CITY of NOVI CITY COUNCIL

Agenda Item
March 22, 2010

SUBJECT: Consideration of the request of Novi Mile, LLC for Zoning Map Amendment 18.694 to rezone property in Section 16, east of Beck Road between I-96 and Grand River Avenue, from OST, Office Service Technology District to FS, Freeway Service District with a Planned Rezoning Overlay. The subject property is approximately 1.81 acres.

PLAN REVIEW CENTER REPORT
March 2, 2010
Planning Review of Concept Plan
46100 Grand River
SP10-11 with Zoning Map Amendment
18.694

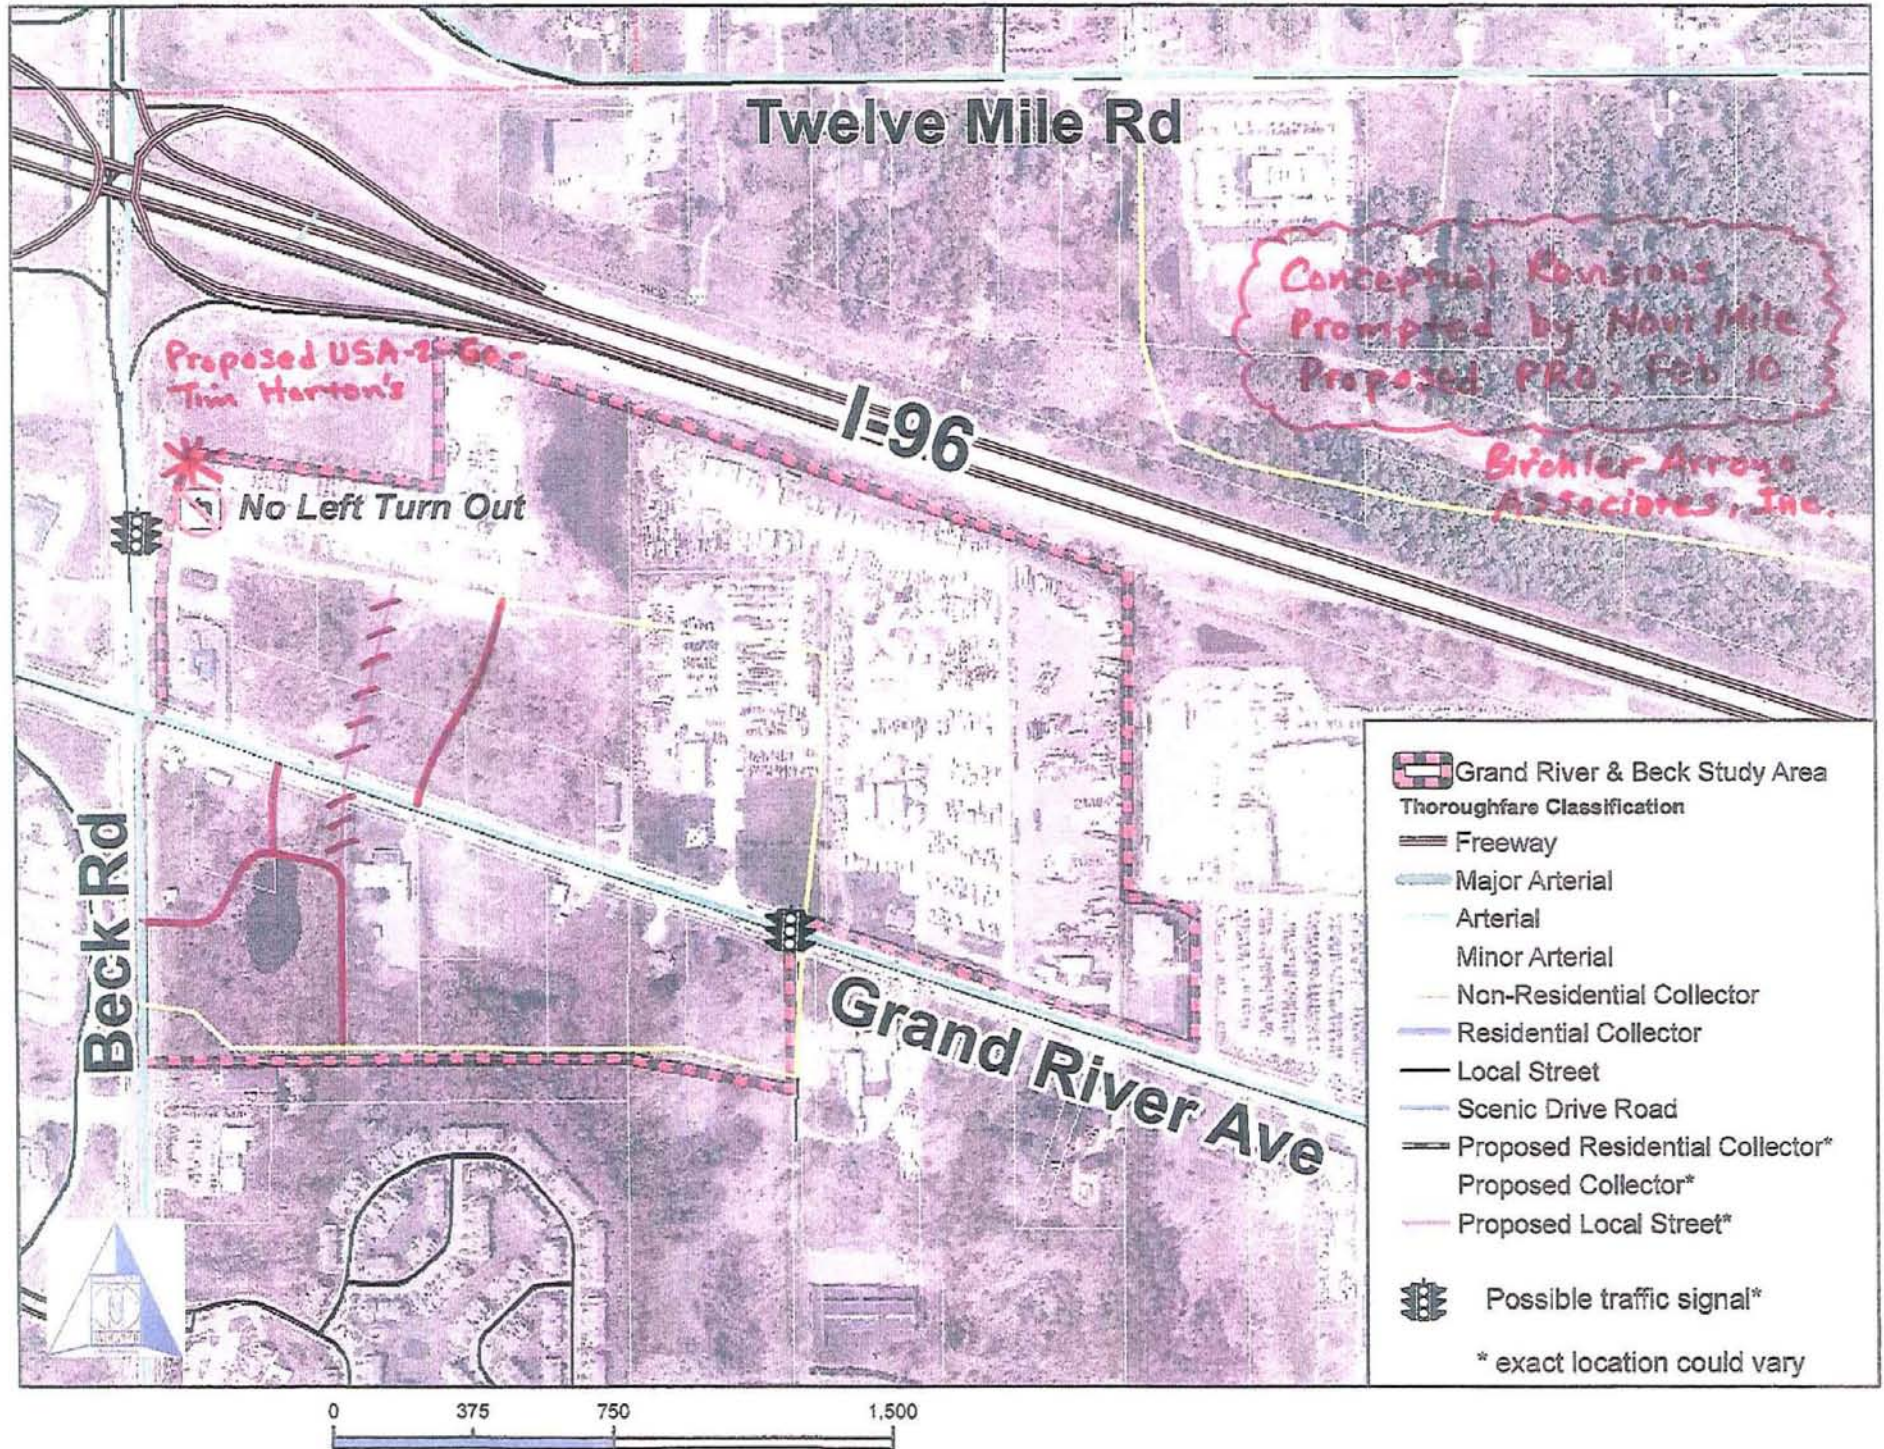
To better accommodate later phases of development contemplated by Novi Mile, LLC, the conceptual PRO now under review proposes that the first north-south connection east of Beck between the east-west collector and Grand River be located somewhat further east than shown in the City's latest concept plan. As can be seen on our attached mark-up of the latter, the connection now proposed would generally connect the frontage of the existing concrete plant (backing up to I-96) to a point directly across Grand River from an existing industrial driveway.

We support the new connector location proposed, and recommend that this change be made to the Master Plan and Zoning Committee's conceptual road plan. Furthermore, to provide a more-than-minimum opposite-side driveway spacing between the northerly connection and a corresponding north-south connection south of Grand River, we recommend that the southerly connection be shifted west one lot line, as shown on the attached mark-up.
